TO: Kristopher Apanian, TAIT & Associates, Inc.
FROM: Amber Wood Hicken, Planner I
DATE: 6/3/25
SUBJECT: Parker Pointe, Auto Parts Store, Site Plan
Review Comments 02

O'REILLY AUTO PARTS PARKER, CO (PK2)

LOT 1 OF PARKER POINTE SUBDIVISION FILING NO 1

13 LANDSCAPE SCREEN WALL

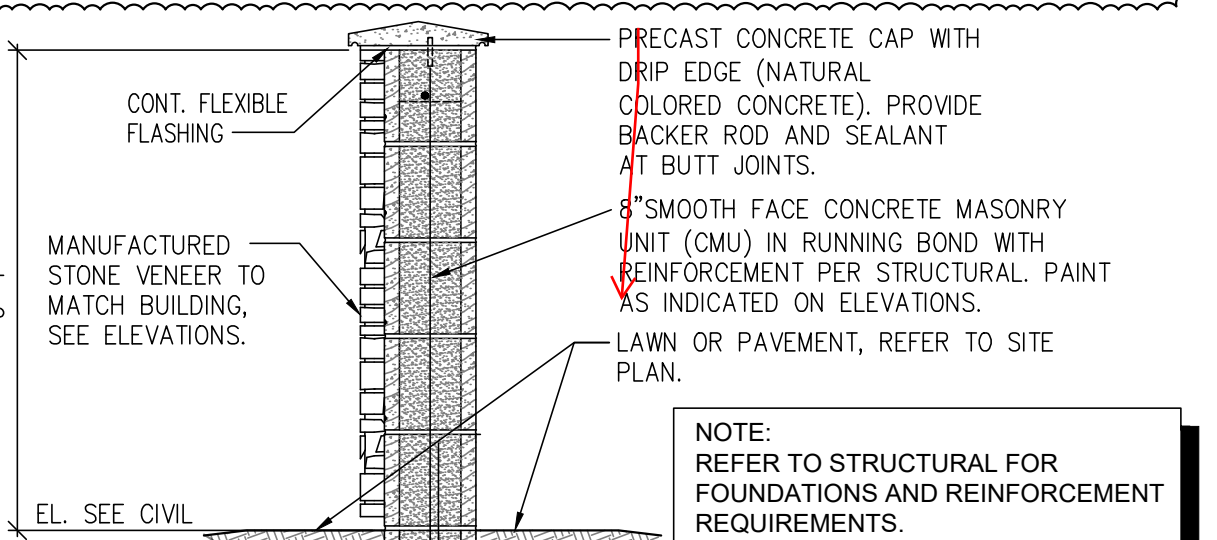
indicate color on this sheet. should match building.

PROJECT: NEW O'REILLY AUTO PARTS STORE
STROH RD
PARKER, CO #2
LANDSCAPE PLAN

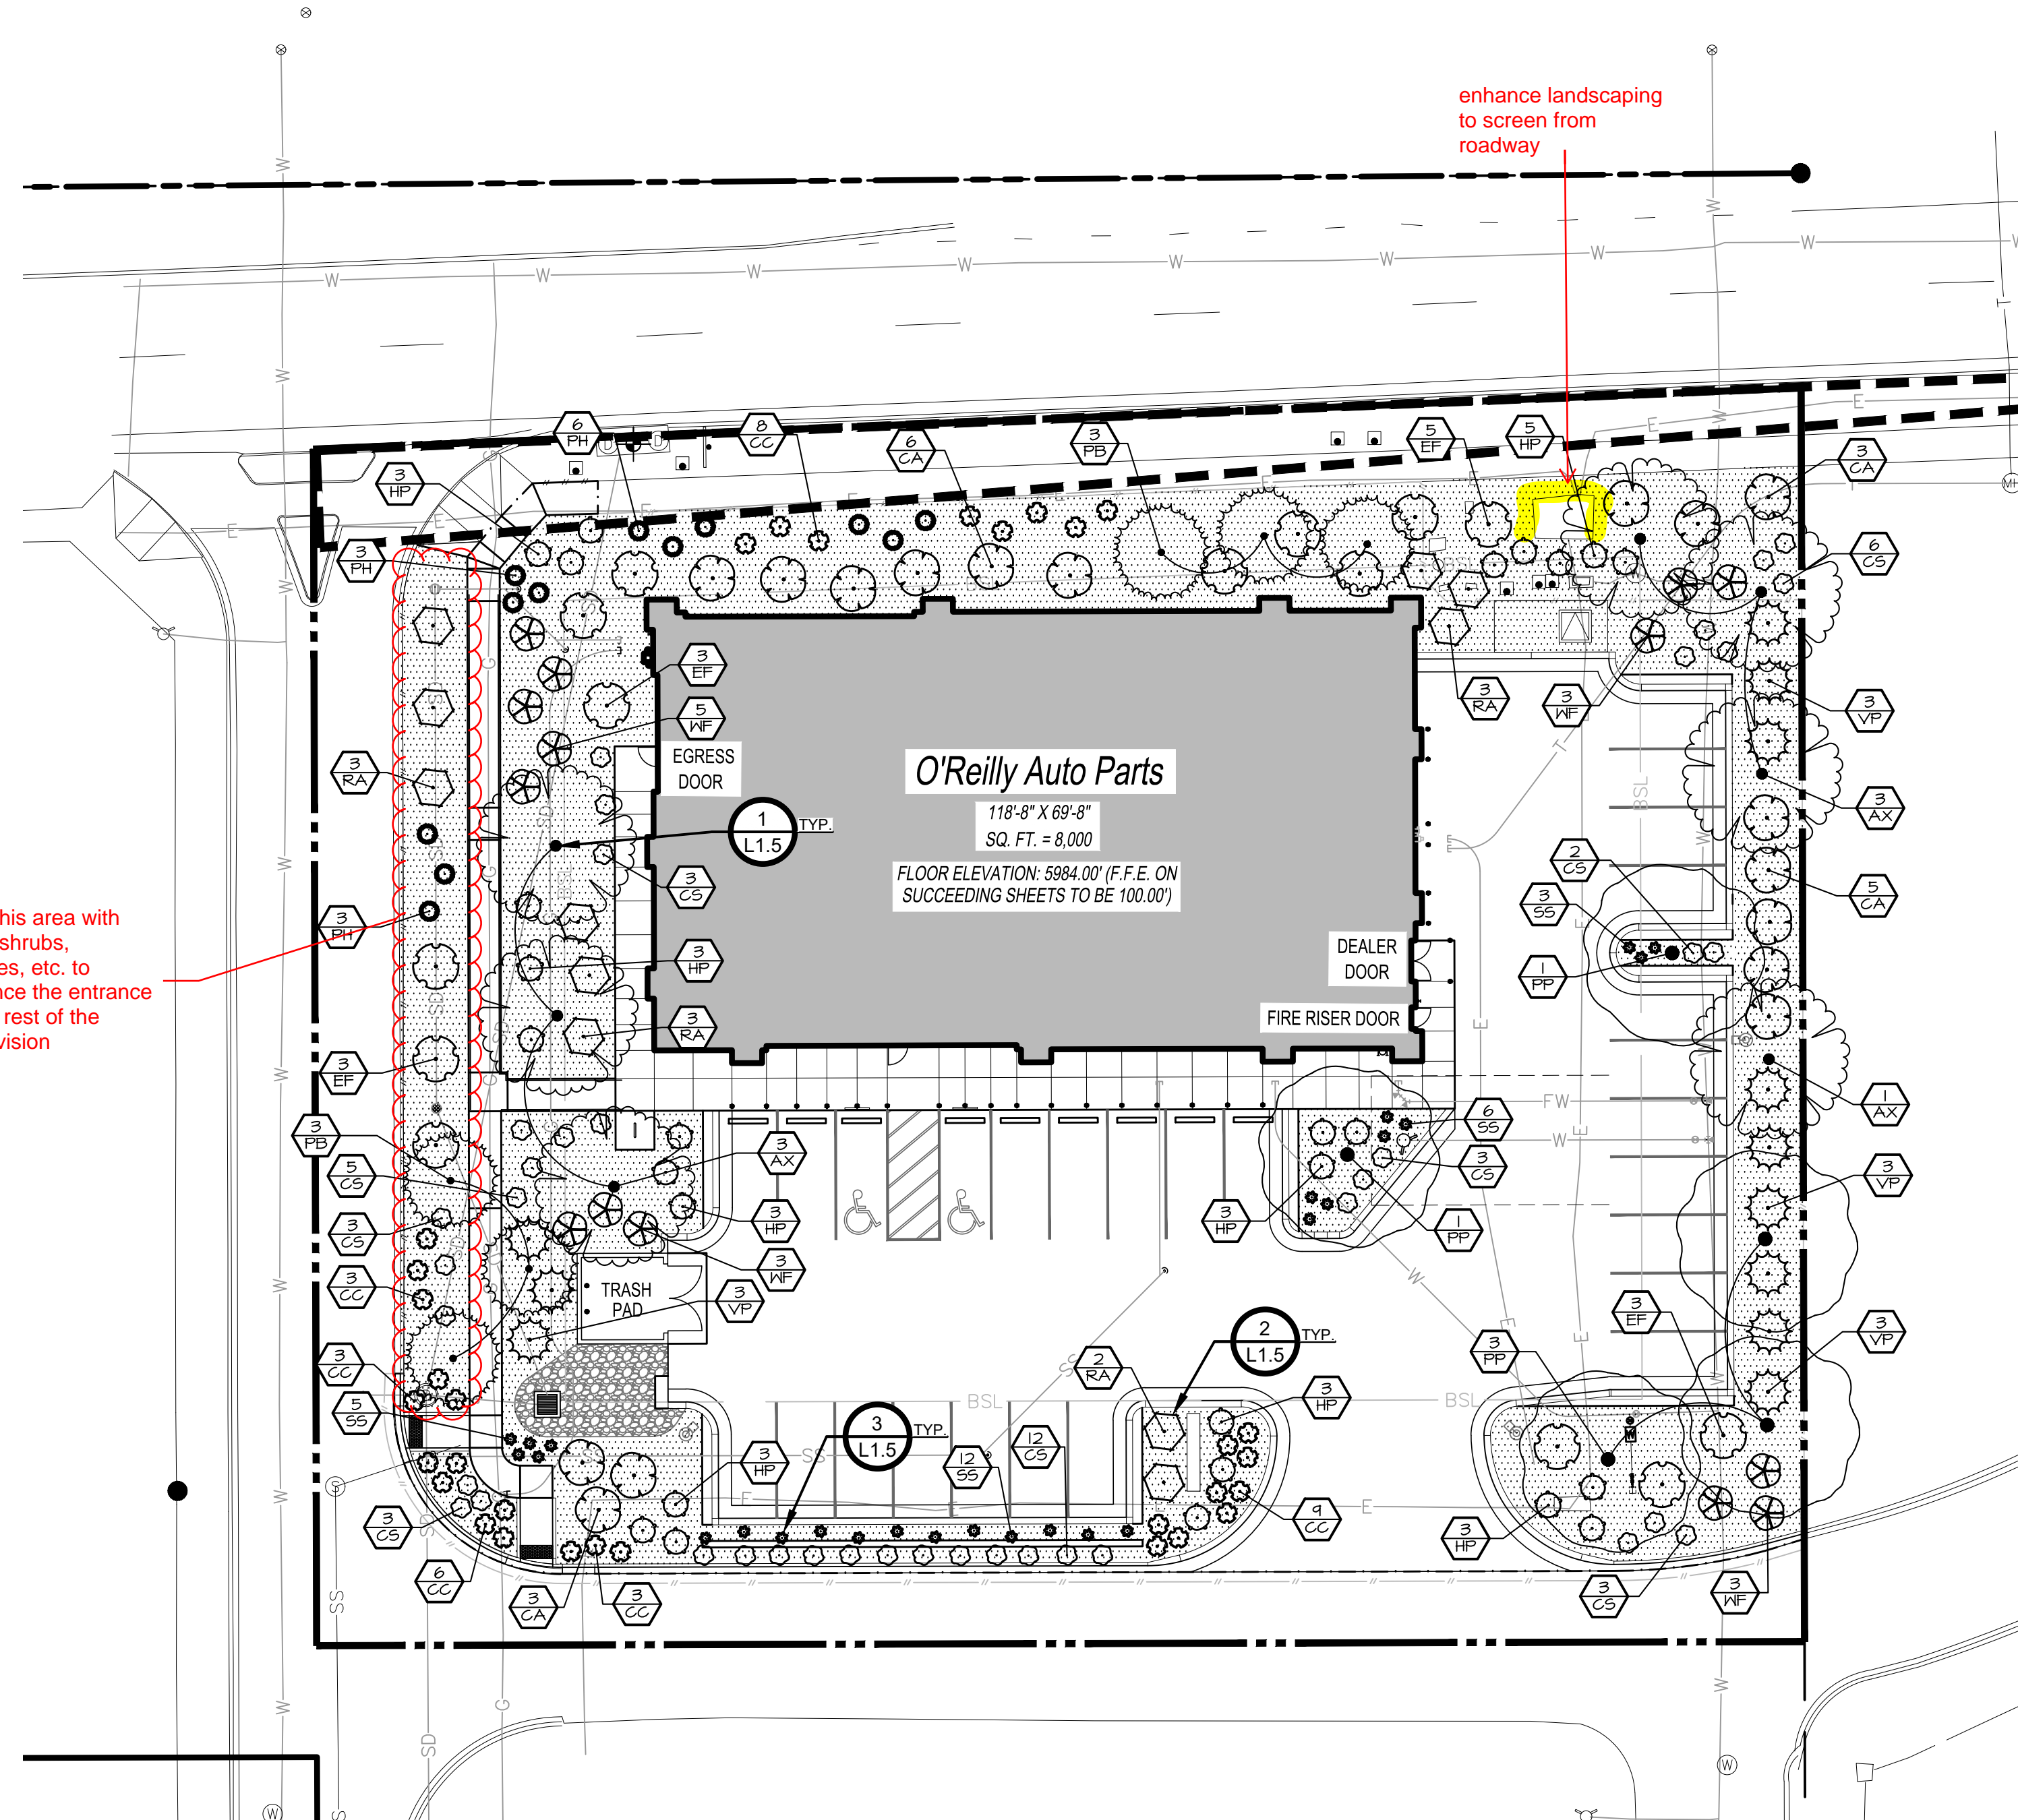
fill in this area with more shrubs, grasses, etc. to enhance the entrance to the rest of the subdivision

enhance landscaping to screen from roadway

show required/provided buffer widths for perimeter landscaping (if width varies, use minimum)

(show square footage and percentage)
